**ZONING AMENDMENT,
PLANNED UNIT DEVELOPMENT &
SUBDIVISION STAFF REPORT****Date: April 21, 2011**

<u>NAME</u>	Davis Companies, LLC
<u>SUBDIVISION NAME</u>	Summer Subdivision
<u>DEVELOPMENT NAME</u>	University Grande Apartment Complex
<u>LOCATION</u>	6133 & 6201 Old Shell Road and 75 & 79 West Drive (Southeast and Southwest corners of Old Shell Road and West Drive)
<u>CITY COUNCIL DISTRICT</u>	District 6
<u>PRESENT ZONING</u>	R-1, Single-Family Residential
<u>PROPOSED ZONING</u>	R-3, Multiple-Family Residential
<u>REASON FOR REZONING</u>	To allow parking associated with a proposed Multi-Family Residential development.
<u>AREA OF PROPERTY</u>	4 Lots/ 10.3± Acre
<u>CONTEMPLATED USE</u>	<p>Subdivision approval to create three legal lots of record from four legal lots; Planned Unit Development Approval to amend a previously approved Planned Unit Development to allow multiple buildings on a single building site, off-site parking and shared access; and Rezoning from R-1, Single-Family Residential District, to R-3, Multiple-Family Residential District, to allow an off-site parking lot for an apartment complex.</p> <p>It should be noted, however, that any use permitted in the proposed dist

SITE PLAN

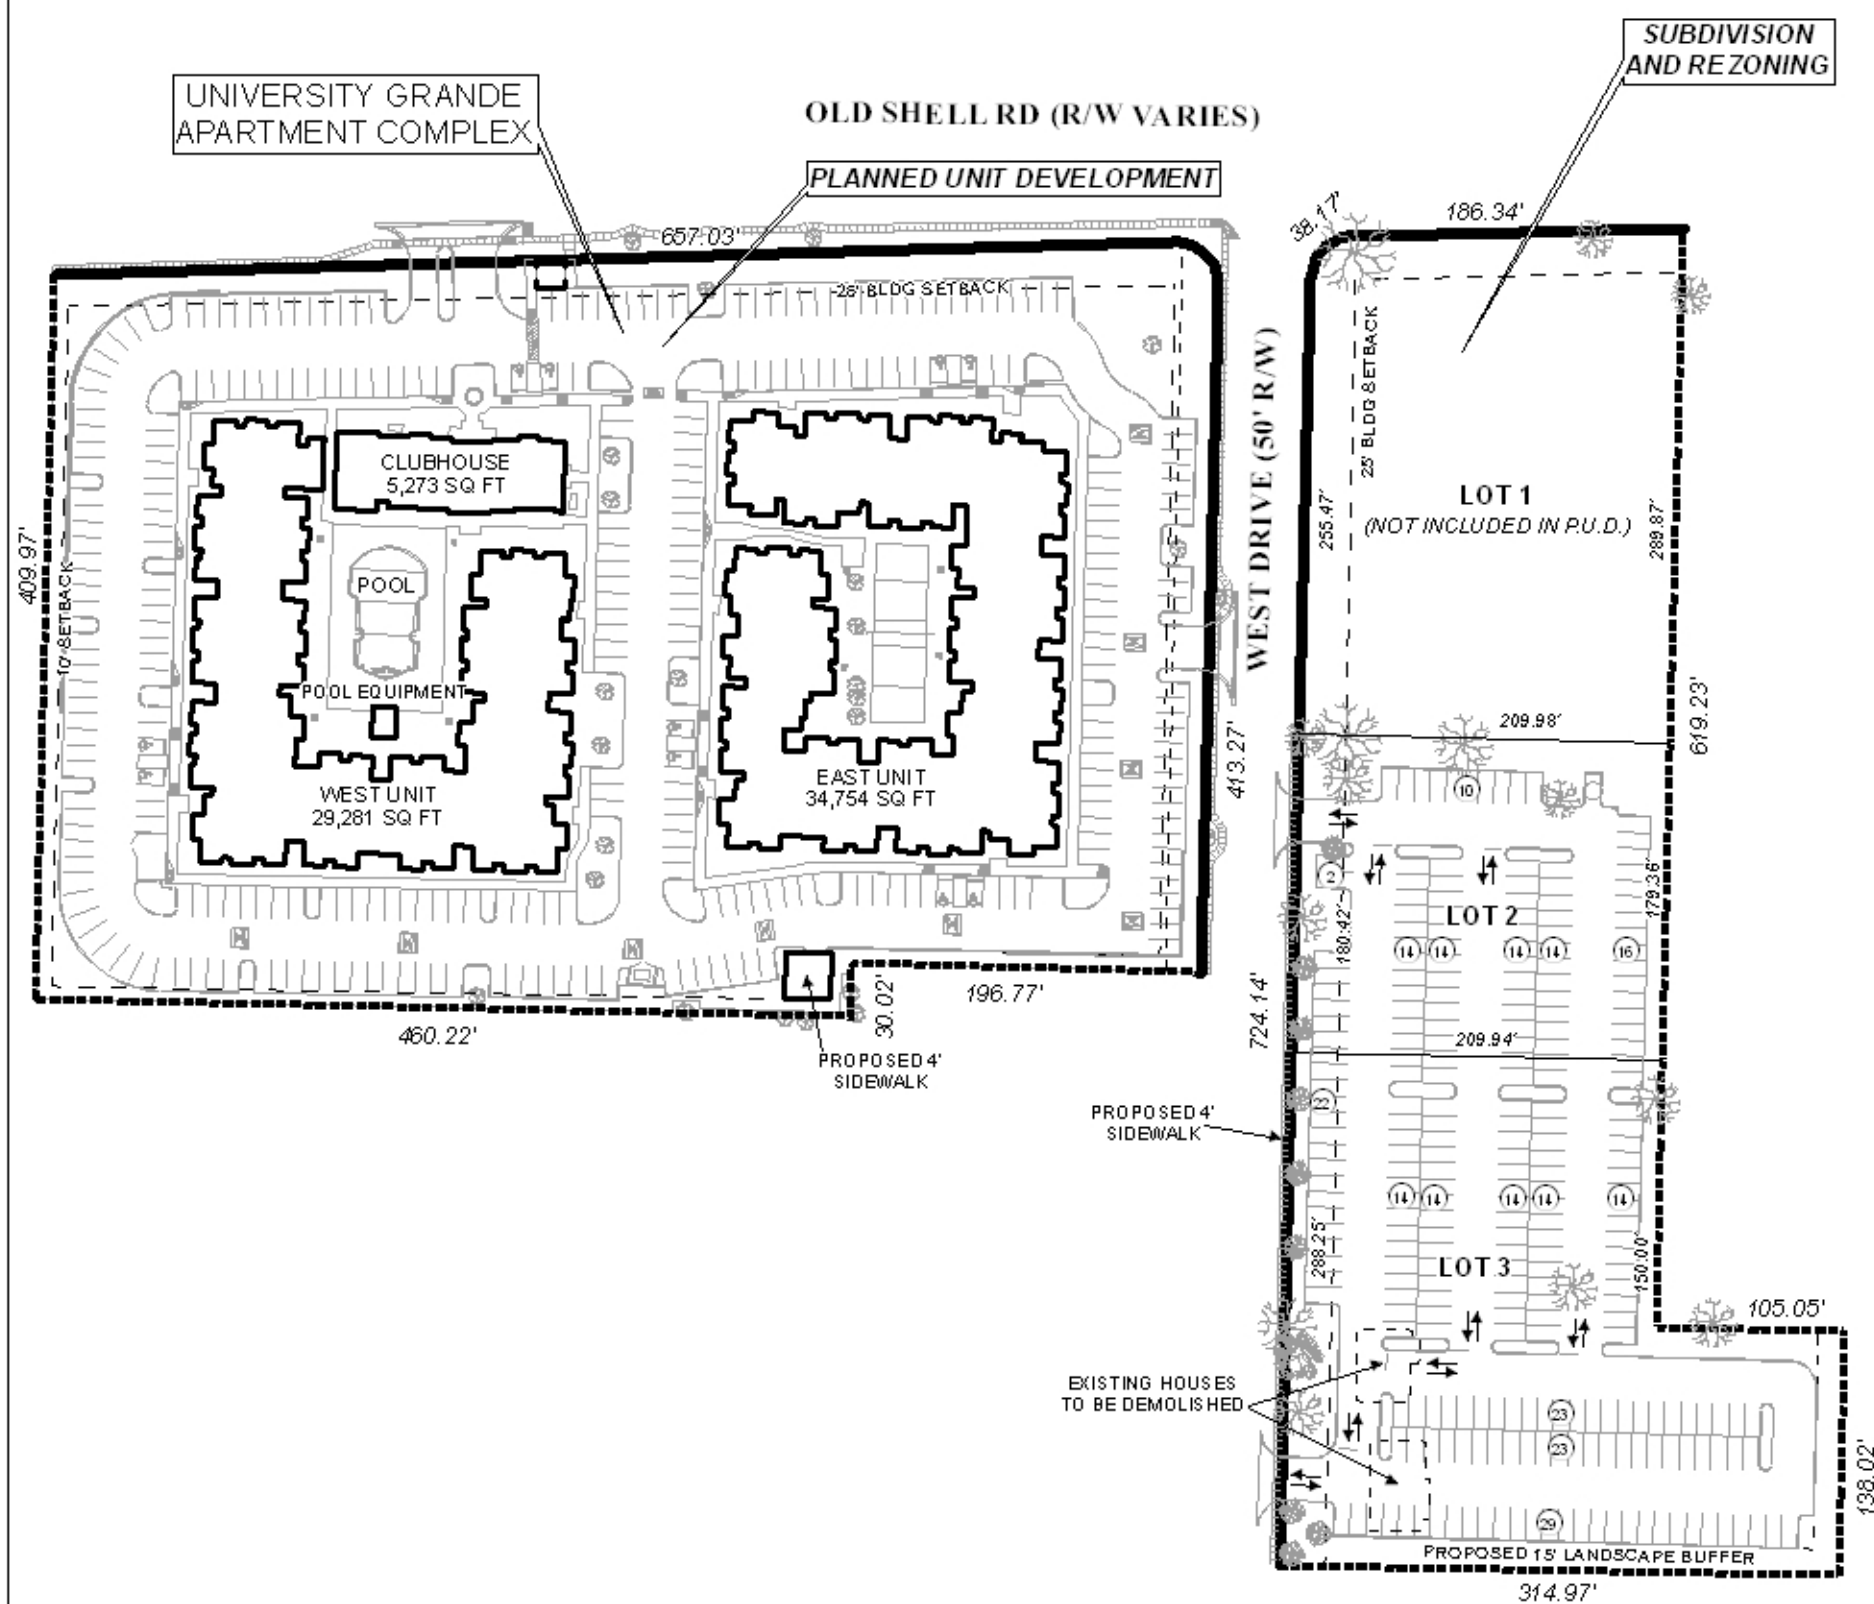
As proposed the applicant is illustrating a 15-foot landscape buffer, the plan does not illustrate a 6-foot high solid wooden fence as required by the Zoning Ordinance for development adjacent to residential development. Also, the Zoning Ordinance requires a 3-foot high wall or hedgerow along West Drive.

The applicant has not submitted a revised preliminary plat combining Lots 2 and 3, illustrating the additions of buffering along the adjacent residential properties and West Drive as required by the Zoning Ordinance and amending the rezoning of Lot 2 from B-2, Neighborhood Business to R-3, Multi-Family Residential.

- 1) additions of buffering along adjacent residential properties and West Drive as required by The Zoning Ordinance;*
- 2) provide an appropriate dumpster enclosure and sanitary sewer connection for all dumpsters on the site;*

- 3) provide signage within the off-site parking lot stating that the lot is for the residents of University Grande Apartment Complex to be approved by Urban Development;*

- 4) provide design and style characteristics for the parking lot;*
- 5) how the lot will be maintained to minimize debris;*
- 6) security measures to enhance safety;*

SUBDIVISION & REZONING DETAIL

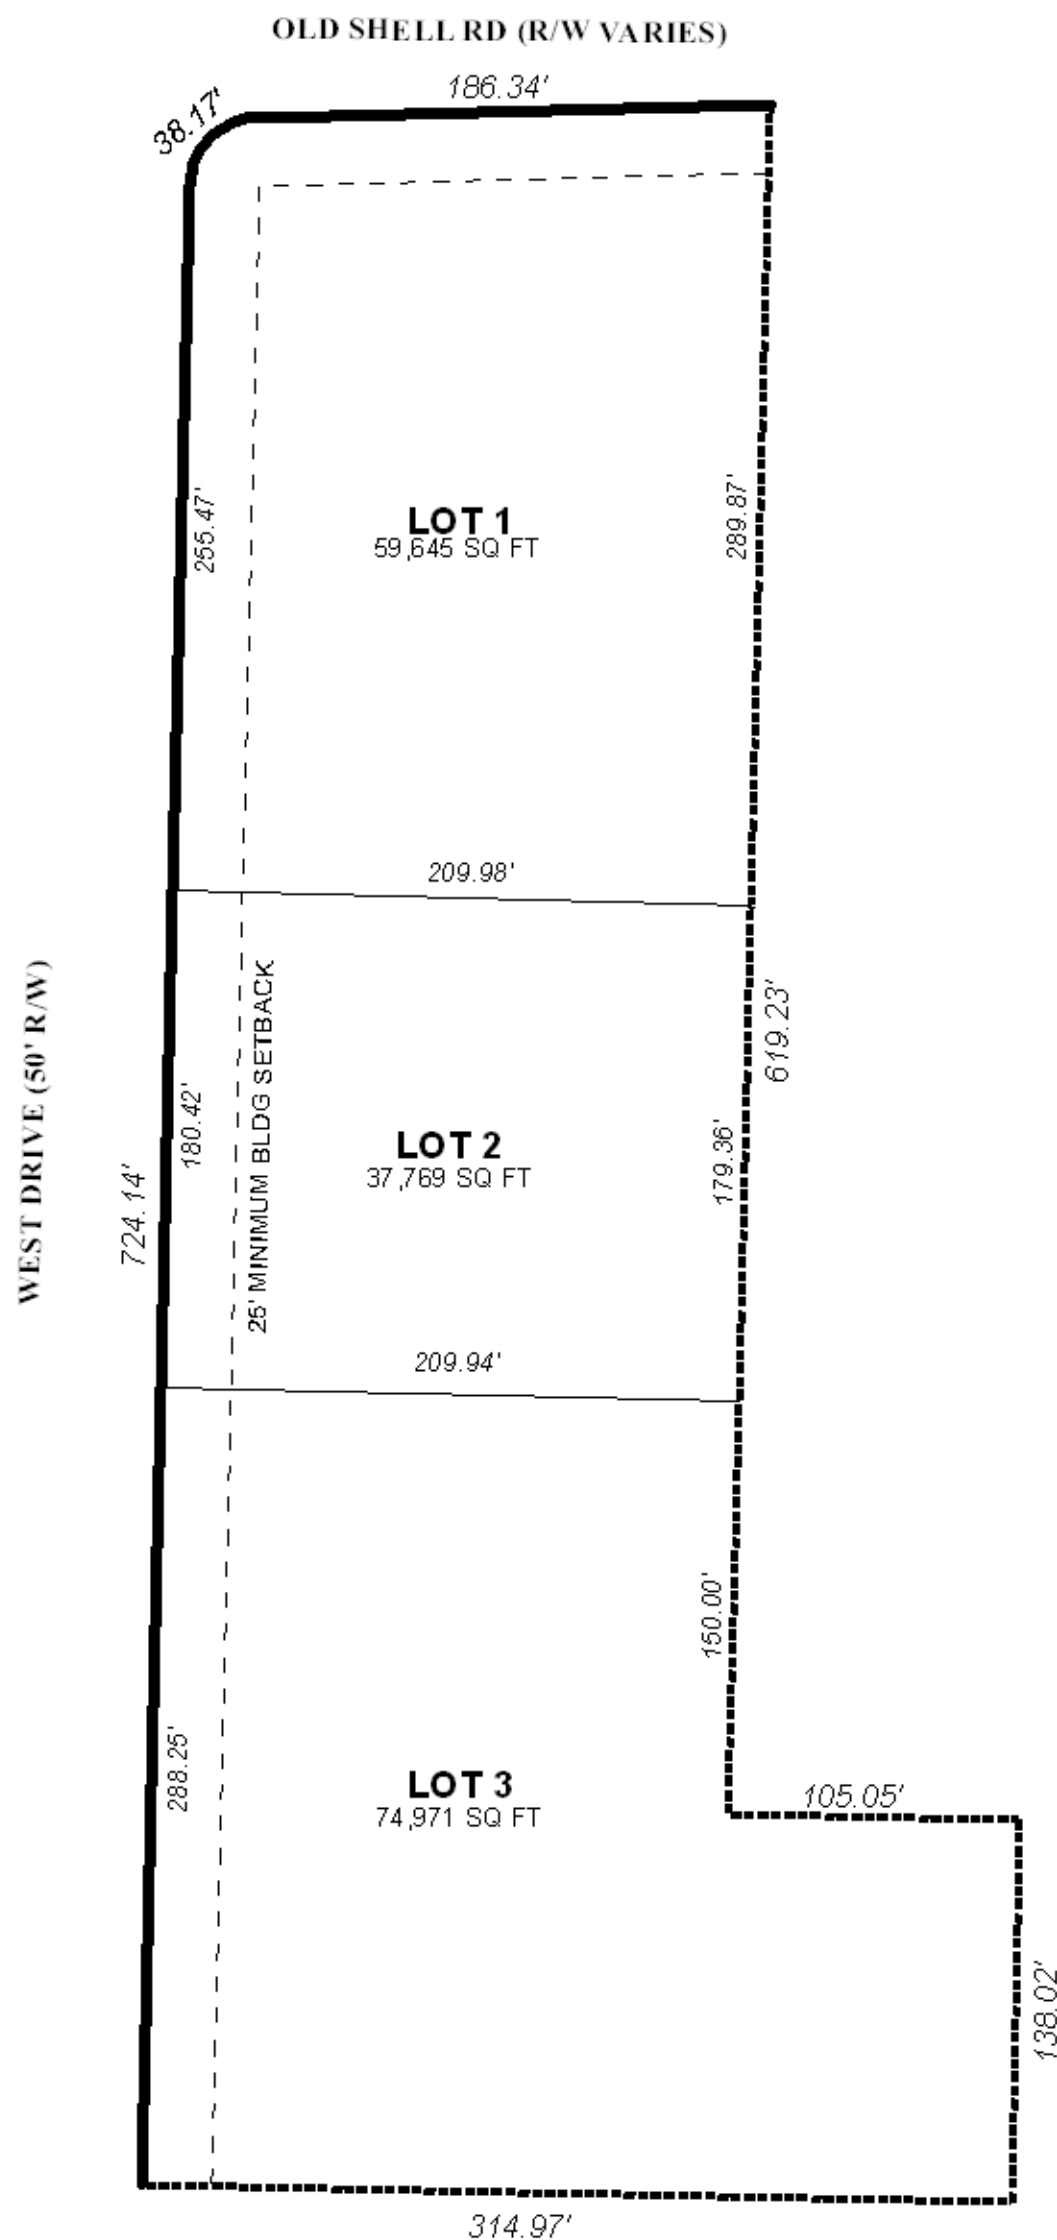
From a planning standpoint Lots 2 and 3 should be combined into one single lot and rezoned to R-3, Multi-Family Residential to avoid the split zoning of single development due to the separation of the proposed apartment complex by West Drive.

As previously mentioned the rezoning from B-2 to R-3 of proposed Lot 2, should be amended, the creation of one lot consisting of the proposed Lots 2 and 3 would create a new R-3 district more in-line with the minimum guidelines.

- 3) *retention of the 25-foot minimum building line along all public rights-of-way, with modifications as necessary due to any required dedication;*
- 4) *combining Lots 2 & 3 into one lot, named Lot 2;*
